AGENDA

July 17, 2014 Standards Committee Meeting

RE: Agenda for the July 17, 2014 Standards Committee Meeting

REVISION TO RECURRING SPECIAL PROVISIONS AND RECURRING PLAN DETAILS
 805-T-173d WIRELESS VEHICLE DETECTORS (WITH MARKUPS)

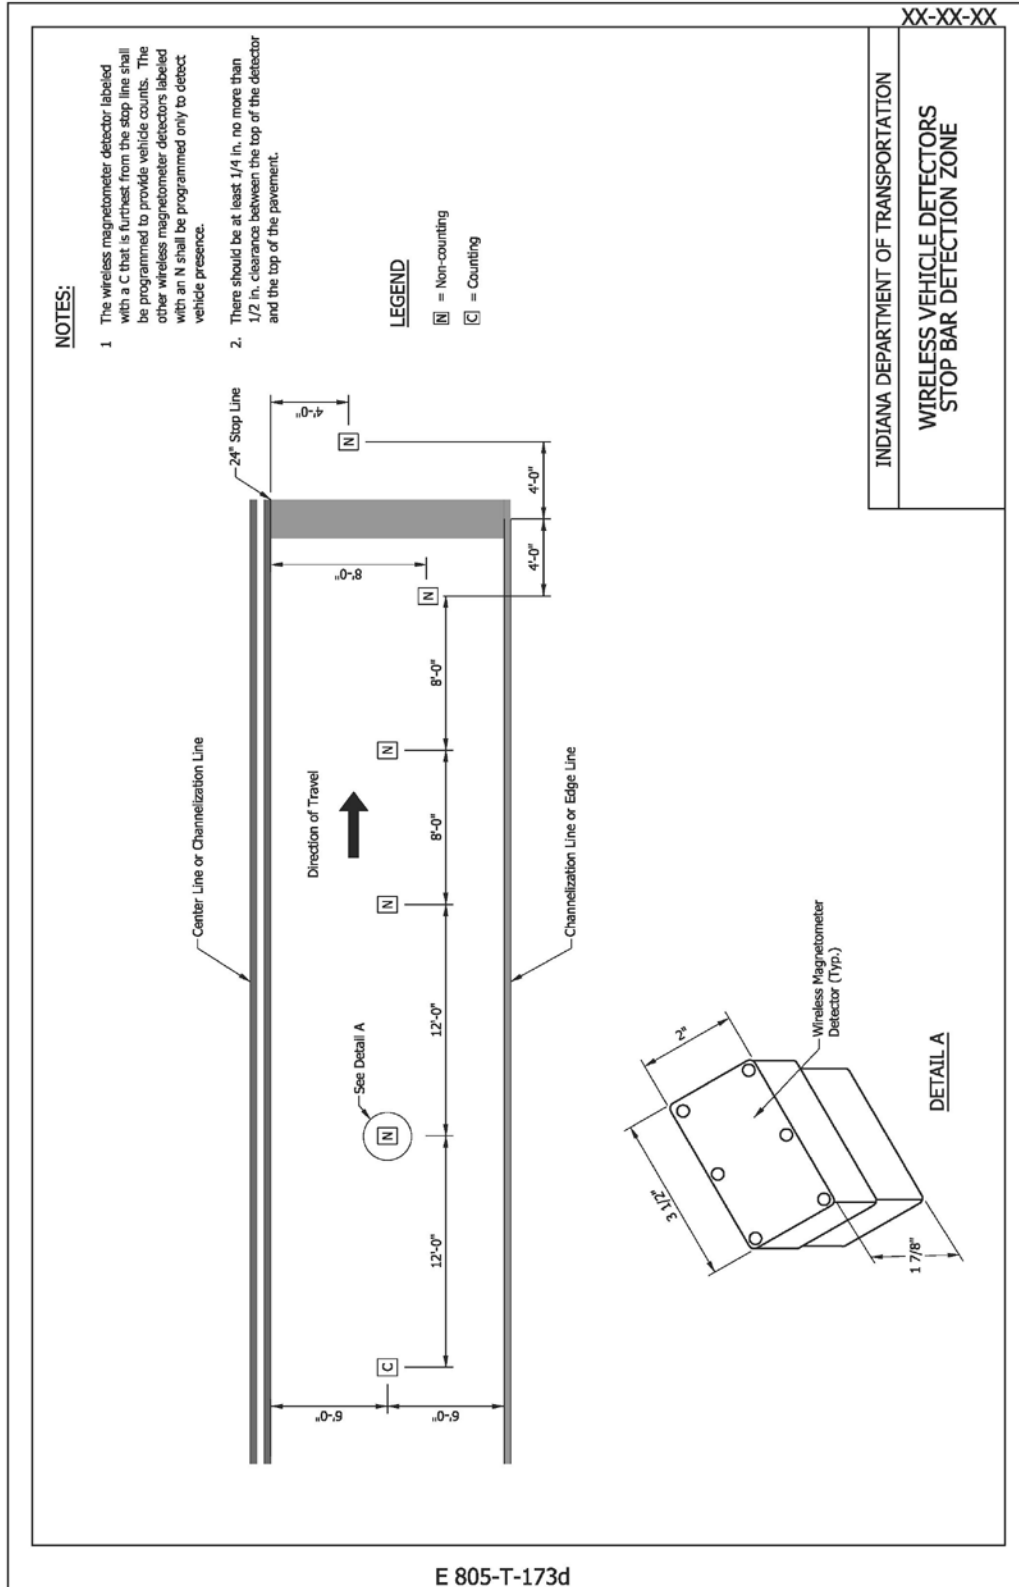
PROBLEM(S) ENCOUNTERED: Recurring Special Provision 805-T-173 and Recurring Plan Detail 805-173d regarding wireless vehicle detection refer to two types of wireless detectors, a type that is capable of counting vehicles and a type that is not. However, it turns out that the type that was thought to be incapable of counting vehicles actually can and the one that INDOT had been buying to count vehicles is more expensive and has extra features that aren't needed.

PROPOSED SOLUTION: In conjunction with updating the approved materials list for Traffic Signal and ITS Control Equipment, eliminate the type description in the pay item and clarify on the recurring plan detail that the detectors can be programmed to count vehicles.

1. The wireless magnetometer labeled with a C that is furthest from the stop line shall be programmed to provide vehicle counts. The other wireless magnetometer detectors labeled with an N shall be programmed only to detect vehicle presence.
